**MRP** Materials Reliability Program \_\_\_\_\_ MRP 2021-020  
(via email)

Subject: Transmit Electric Power Research Institute NEI 03-08 Interim Guidance MRP 2021-005  
Related to B&W-Designed Core Barrels to NRC for Information

Subject: NEI “Needed” Interim Guidance regarding MRP-227-A and MRP-227, Revision 1-A B&W Core Barrel Cylinder Top Flange Circumferential Weld Heat-Affected Zone Inspection

**CUSTOMER SERVICE BULLETIN NO. 21-04**

**Figure 1: Location of CB Cylinder Top Flange Circumferential Weld – B&W-Designed PWRs**

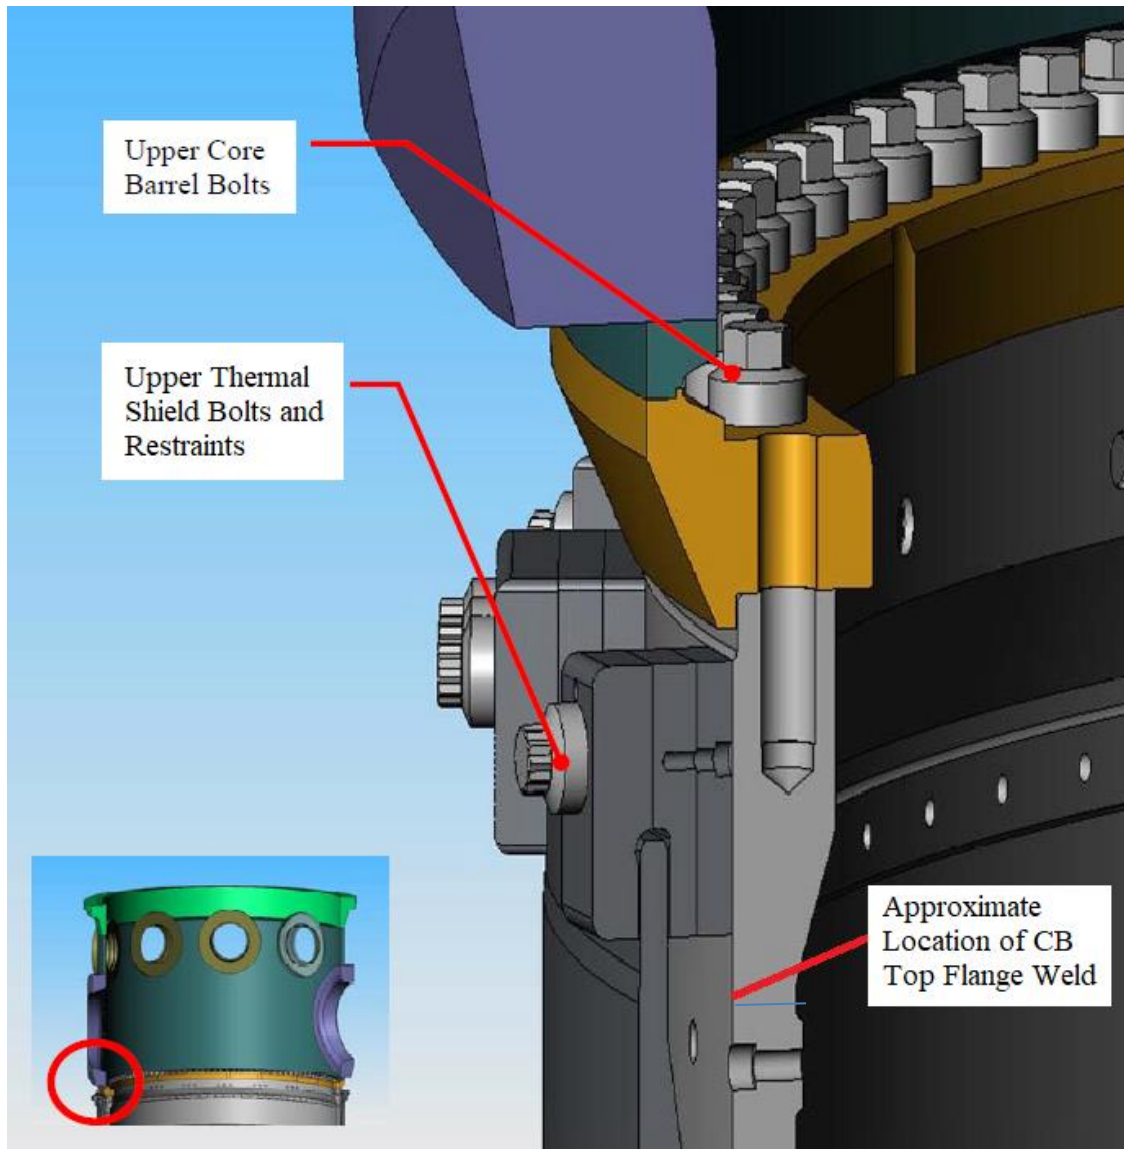
The CB cylinder top flange circumferential weld HAZ shall be the Primary item for SCC for units that had weld repairs performed on their top flange circumferential weld after the stress relief. There are no associated Expansion items.

The CB cylinder top flange circumferential weld HAZ is “Primary” because this location is screened as susceptible to SCC (as well as irradiation embrittlement), an indication could become functionally significant, and there are no other locations that could act as a leading indicator. The base metal adjacent to the weld (i.e., HAZ) is the focus because the weld metal was screened out for SCC because of the ferrite content.

Primary Item: CB cylinder top flange circumferential weld HAZ; see Figure 1

Effect (Mechanism): Cracking (SCC, IE), including detection of surface-breaking crack-like indications

Examination Method: Enhanced visual (EVT-1), volumetric (UT), or eddy current (ECT) examination

Examination Coverage: 100% of the accessible outer diameter (OD) surfaces of  $\frac{3}{4}$ ” of the adjacent base metal to the top flange circumferential weld, as defined in MRP-228 [Reference 5]. Examination coverage requires a minimum of 50% of the length of the specified surface of the weld being examined due to the potential obstruction of the upper thermal shield restraints at the top of the core barrel cylinder.

Initial Inspection: At the time of the next planned RV internals removal (i.e., coinciding with the next 10-year in-service inspection [ISI] of the RV internals)

Subsequent Inspection: During each 10-year ISI interval unless evaluation can justify otherwise (note that such an evaluation would require submittal to the NRC for approval)

Examination Acceptance Criteria: The absence of a relevant condition (i.e., the specific relevant condition is a detectable crack-like surface indication)
